# PITT ST SOUTH

OVER STATION DEVELOPMENT

RESPONSE TO SUBMISSIONS

SEPTEMBER 2020

**SSDA**  
10SQM BALCONY

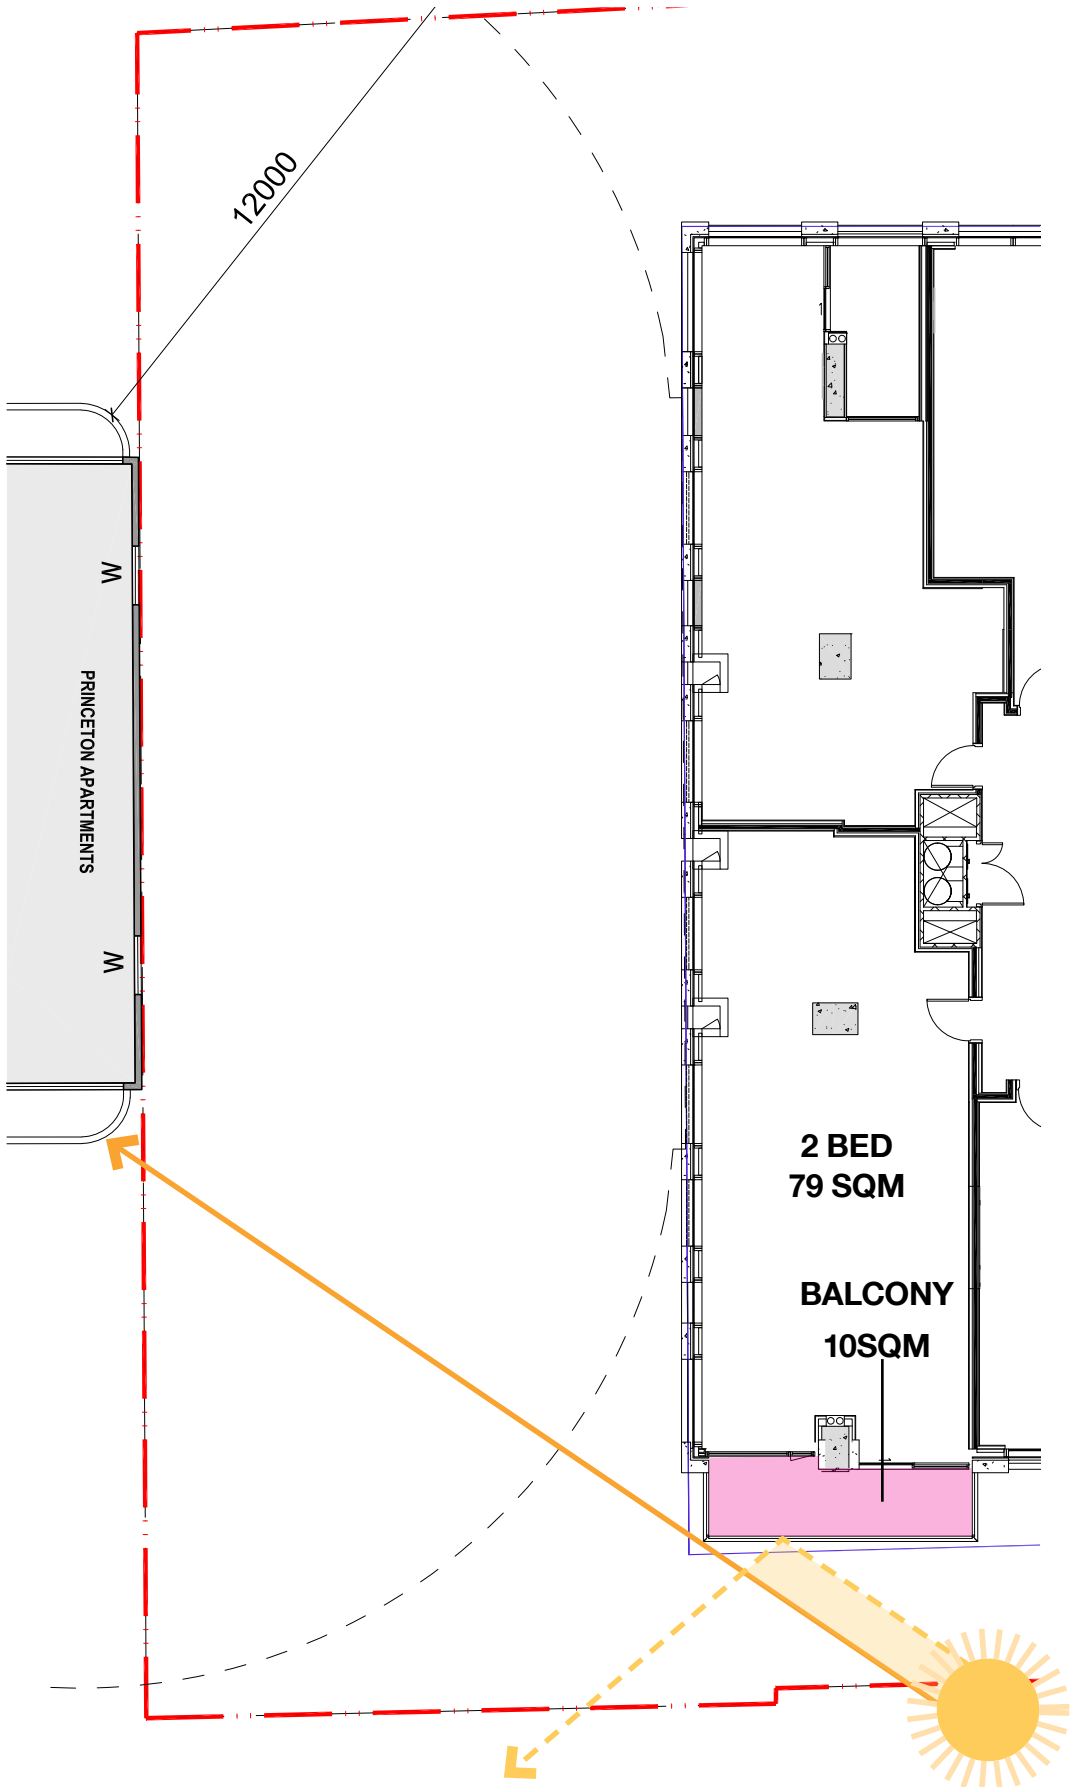
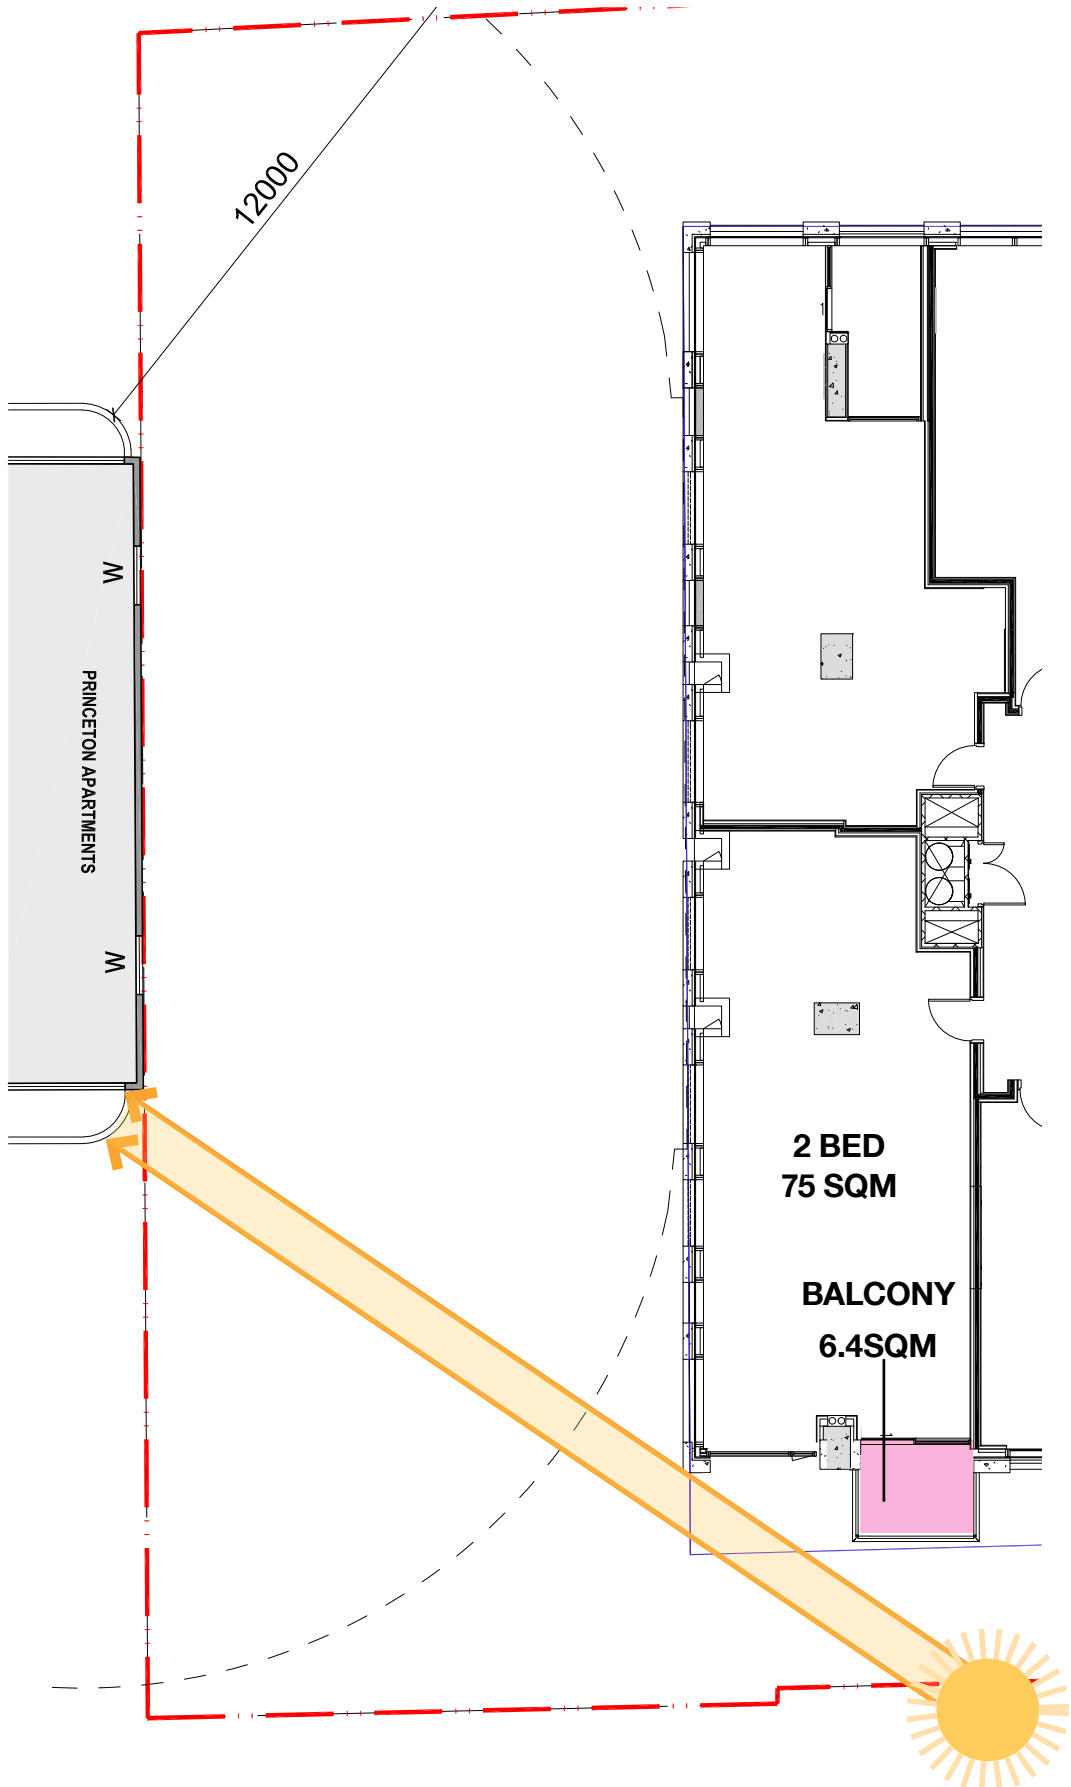
(a) Demonstrate compliance with Condition B3 of the Concept Approval, and provide detailed illustrations showing how the proposed built form satisfies the following subclauses:

\* (e) a varied setback from the Pitt Street boundary of the site, with the articulation of built forms be designed to minimise solar impacts to the living rooms of Princeton Apartments

Although it is not possible to provide a materially increased setback to the South Western without significant loss of amenity to the proposed development, a similar sensitivity analysis described in section 3 of this report has determined that it is possible to achieve a material increase in setback on the South Eastern corner with negligible amenity impacts if agreed as beneficial to Princeton Apartments.

Provided a relaxation in balcony area from 10sqm to 6.5sqm is permissible to the 2 bedroom apartment type facing East, it is possible to increase setback at the south eastern corner by a further 2 metres which will provide some improvement to solar access of Princeton (described in section 3) as well as view outlook from both Princeton and Century Tower (described in section 2).

**PROPOSED**  
6.4SQM BALCONY

SSDA SOUTH EAST APARTMENT

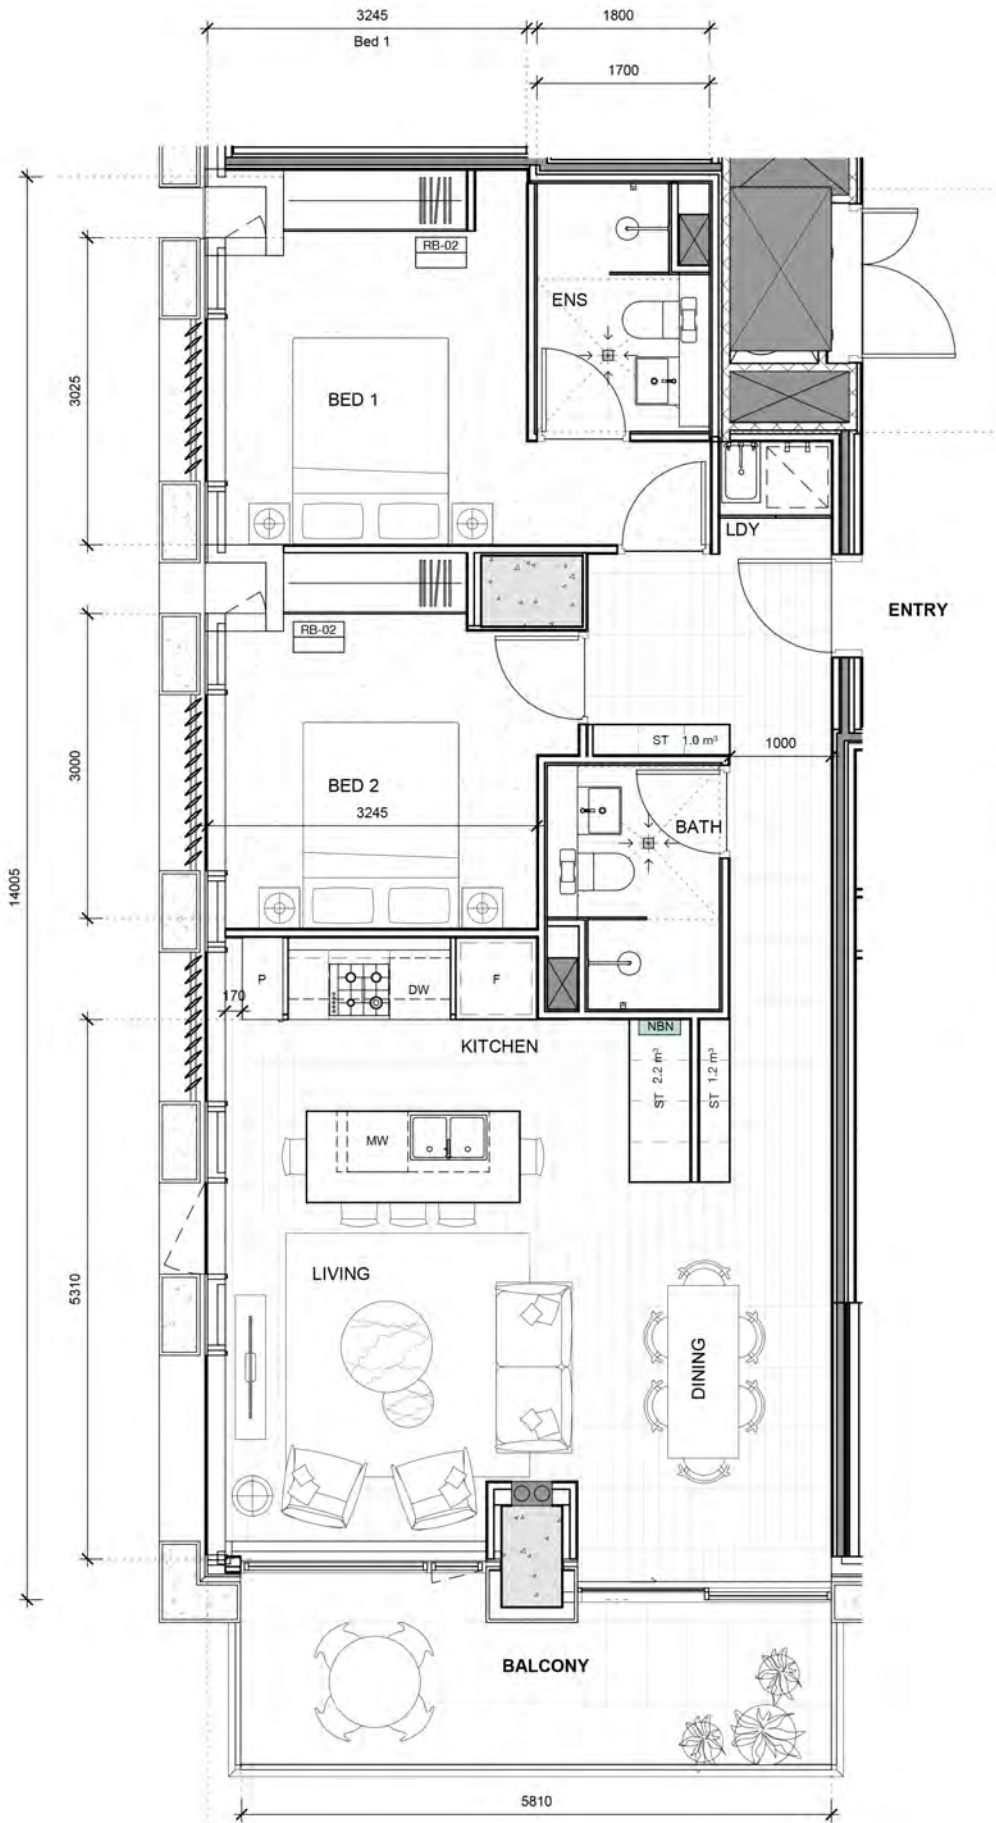
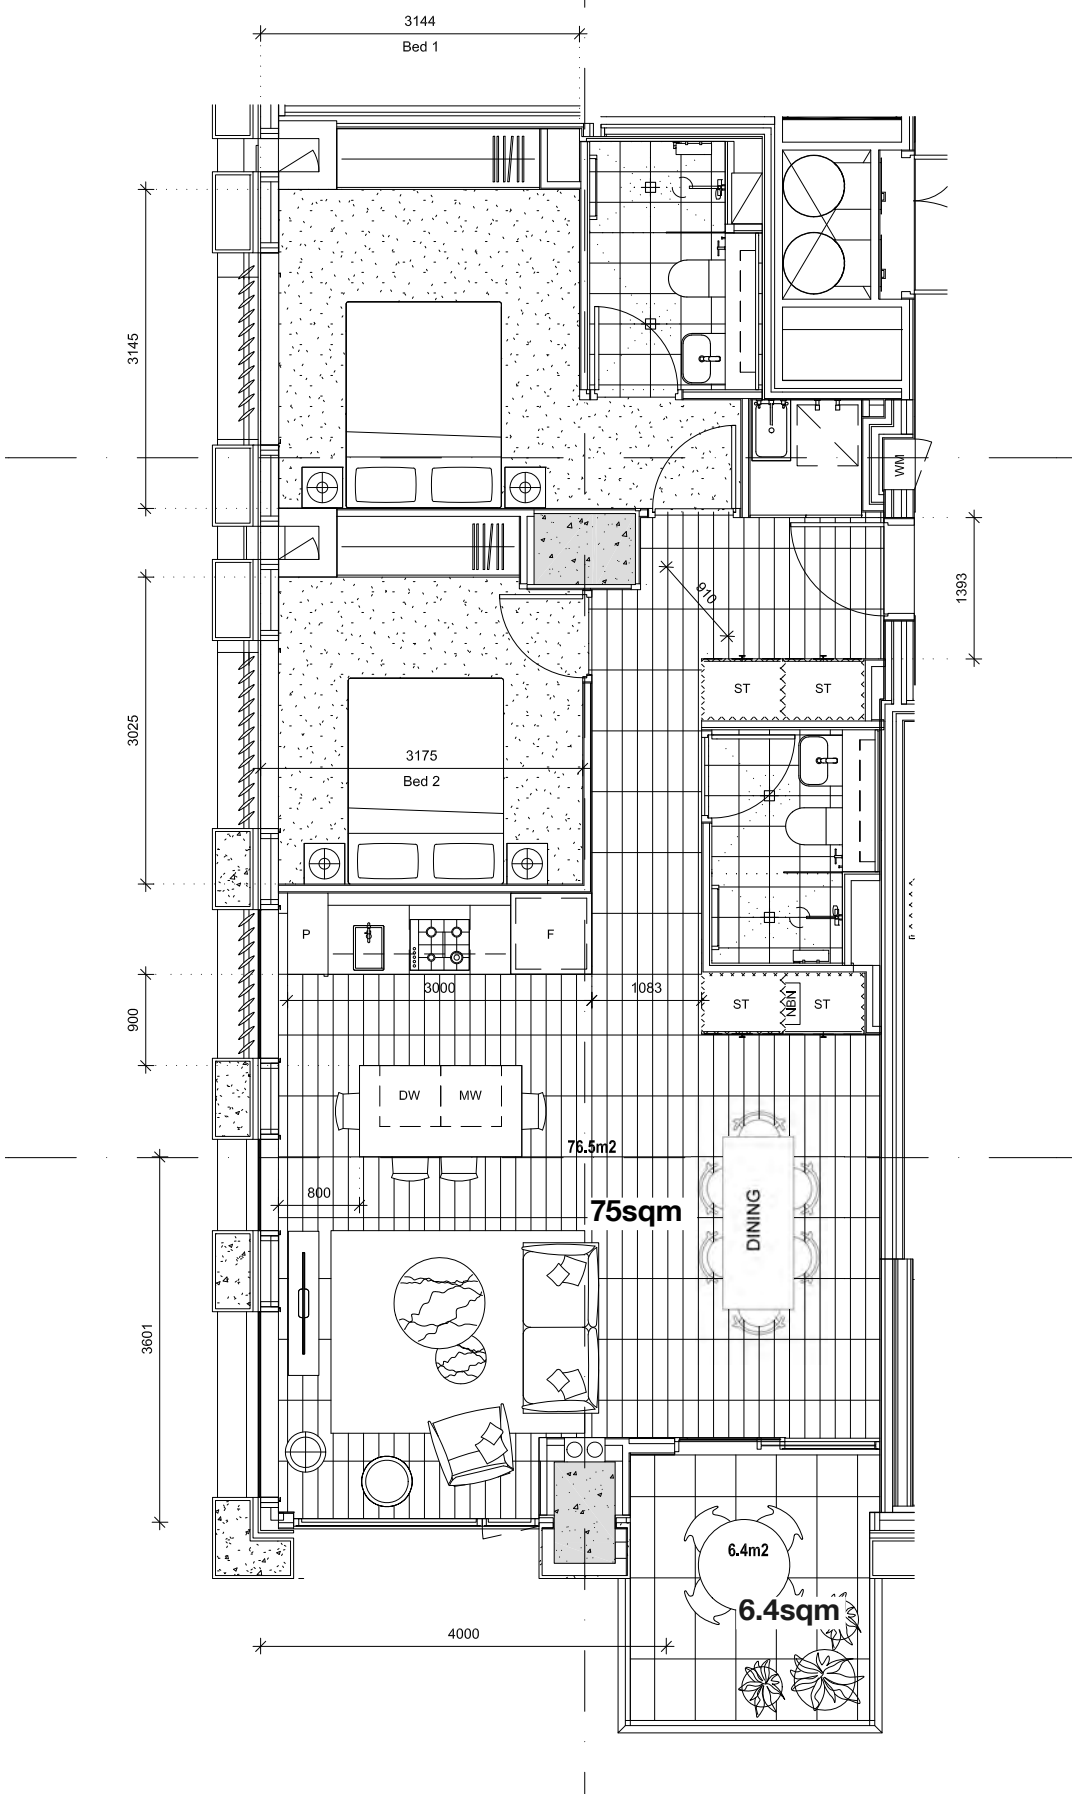
*(b) Provide additional shadow analysis of the proposal’s overshadowing impact on the Princeton Apartments. This must detail the amount of solar access (nil, 0-30 minutes, 30–60 minutes, 60-90 minutes, 90-120 minutes and >120 minutes) the dwellings within Princeton Apartments would receive between 9am and 3pm, 21 June (existing and proposed). Any discrepancies between the number of dwellings maintaining solar access between the Concept Approval assessment and the proposal must be clarified.*

The resulting SSD DA and amended proposed RTS Amended SE apartment configuration is shown adjacent and is as per Option 2 in the table on the previous page.

- Amenity Benefits to Princeton Apartments:
- / Improved solar access from the north east in mornings,
  - / Improved view outlook towards North East

- Requires two planning concessions:
- / 3 x fewer apartments achieving >2 hours solar access on 21st June (this 50% revised total in lieu of 50.9%)
  - / The 2 balcony of the 2 bedroom apartment can only achieve 6.5sqm and not 10sqm as proposed under the ADG.
